**AIA®****Document G701® – 2017****Change Order**

**PROJECT:** *(Name and address)*  
 Wheaton Community Center  
 Interior Renovation, Phase 2

**CHANGE ORDER INFORMATION:**  
 Change Order Number: 004  
 Date: 22 April 2024

COPYRIGHT 2024 SENTINEL TECHNOLOGIES, INC.	
ADDITIONAL DATA OUTLETS	TSK021424
WHEATON PARK DISTRICT	1/8" = 1' - 0"
COMMUNITY CENTER RENOVATION	2/14/2024
 <b>SENTINEL</b>

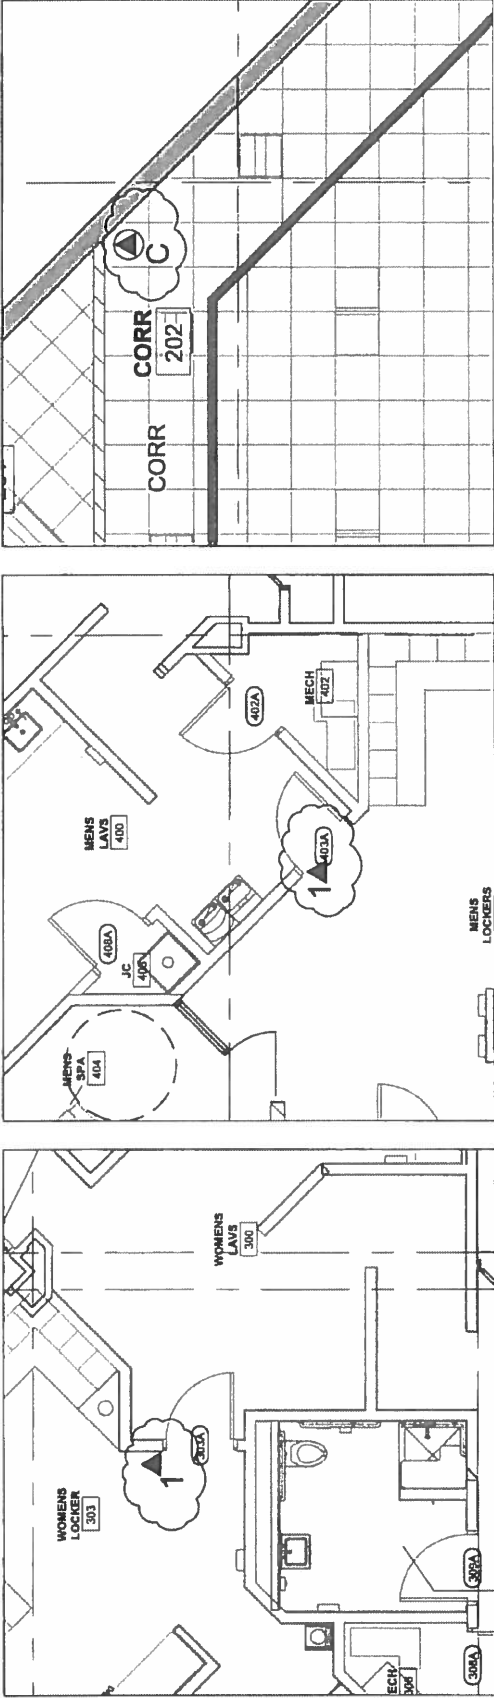
**Description:** TSK 2-14-24 Cabling request

- FURNISH AND INSTALL THREE (3) ADDITIONAL DATA OUTLET LOCATIONS, EACH CONSISTING OF A SINGLE DATA JACK.
- AT LOCKER ROOM ENTRANCES, INSTALL ABOVE FINISHED CEILING BY INSIDE OF DOOR HEADER TO ACCOMMODATE A DATA CONNECTION FOR ACCESS CONTROL DEVICE (FURNISHED AND INSTALLED BY OTHERS). CONFIRM EXACT LOCATION WITH OWNER BEFORE INSTALLATION.
  - IN CORRIDOR 202, A NEW (FUTURE) CAMERA LOCATION. CAMERA FURNISHED AND INSTALLED BY OWNER.
- COMPLY WITH PROJECT SPECIFICATIONS FOR INSTALLATION.

1. (3) Category 6 cables to (3) 1D locations.
2. (3) Category 6 jacks, and (3) surface mount boxes.
3. Test & certify (3) Category 6 cables.
